Construction Division
Additions & Alteration Charges Approval Form

Company Name:	MRMLLP	Site	Gulmohar Residency
Name of the customer	Asura Chendra Shaker Reddy		
Villa/ Flat No.	G-504.

GULMOHAR RESIDENCY

Details of Additions & Alterations

Description WORKING PLAN-1360 5B-A1 TYPE	Direction N 	Owners & Developers Modi Reality Mallapur LLP Project Name & Phase Guilmohar Residency	Date 25.09.2020 Prepared By Jagapada Approved By Saham Modi Scale N.T.S.	Presented By Modi Properties Pvt Ltd Phone: +91-9846133533
---	--	---	---	--

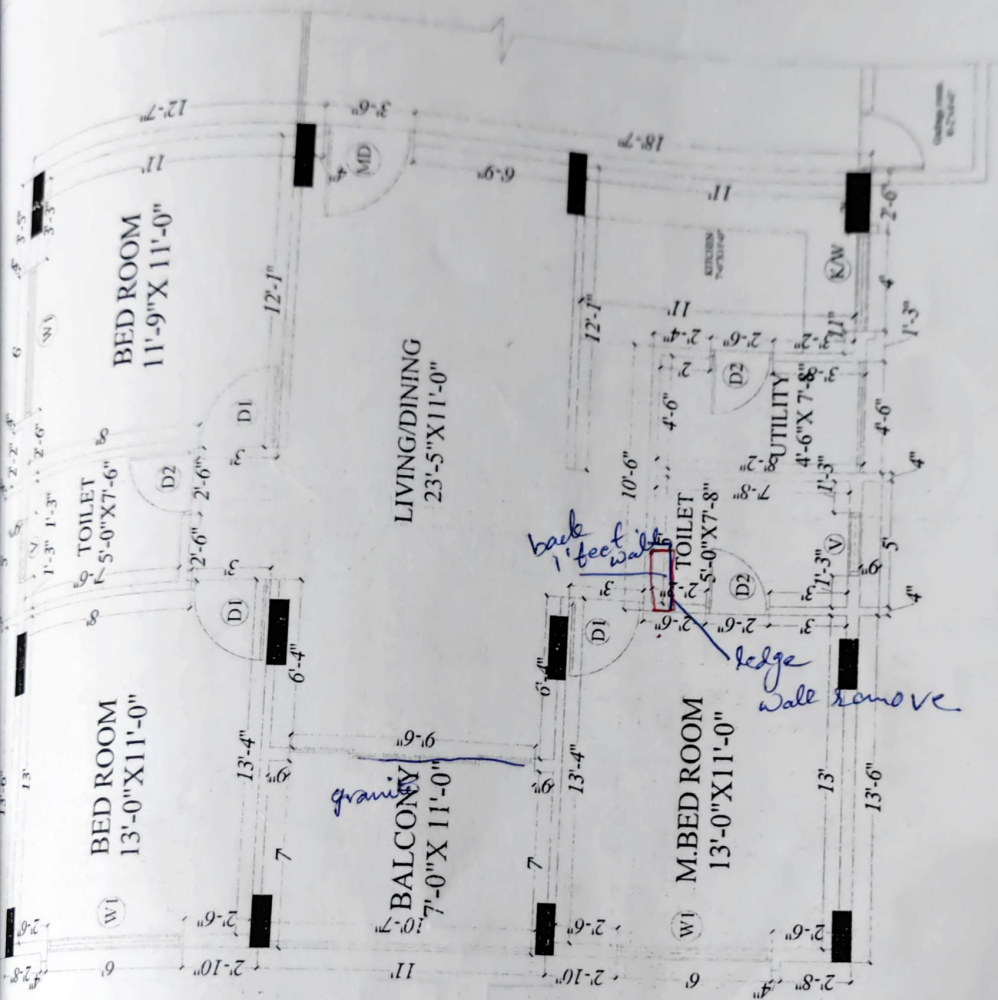
Changes in kitchen platform: (mark on plan)

① kitchen utility platform full upto wall

Description		Direction	Owners & Developers :	Date :	Promoted by :
PLUMBING PLAN-1360 Sft (A1-TYPE)			Modi Reality Mallapur LLP Project Name & Phase : Gulmohar Residency	16.09.20	Promoted by :
				Prepared By :	Modi Properties Pvt Ltd
				Approved By :	Soham Modi
				Scale :	N.T.S

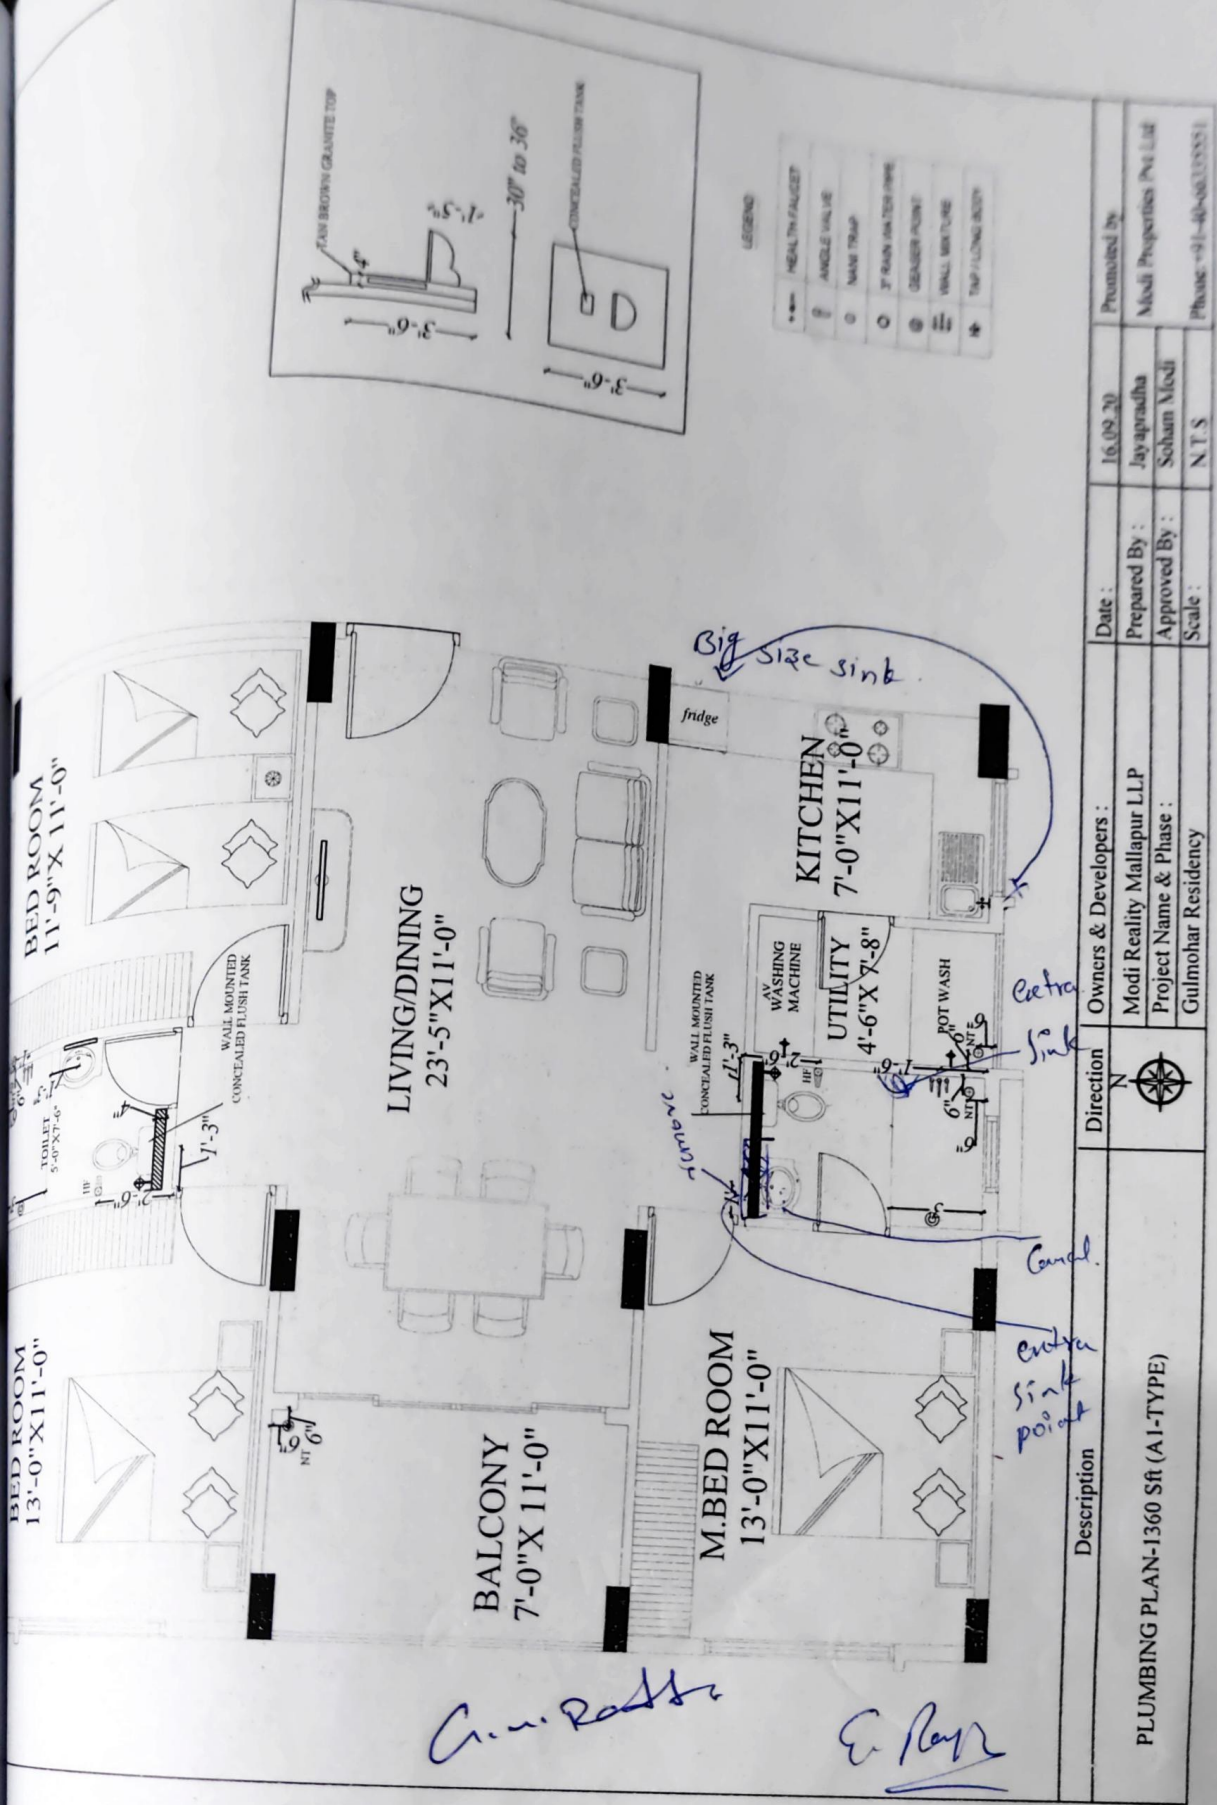
① Sink points changed in w. toilet.

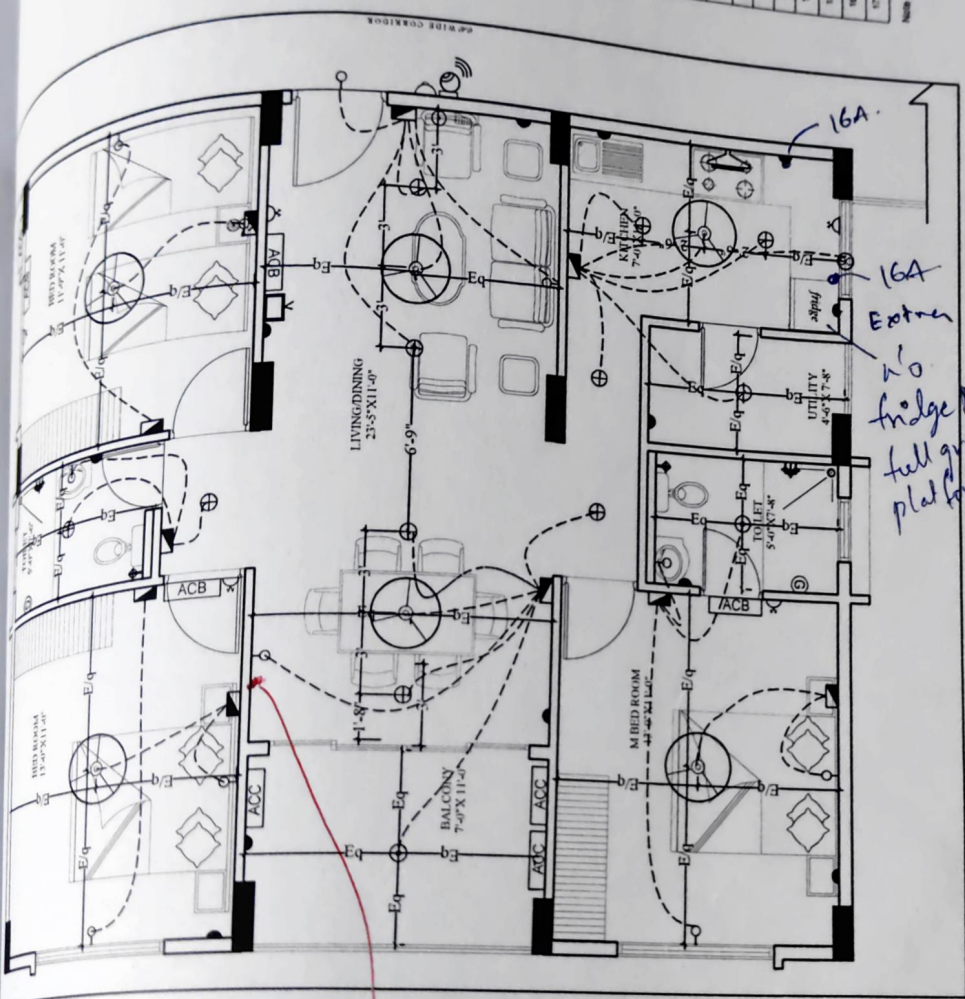
Changes in electrical points: (mark on plan)
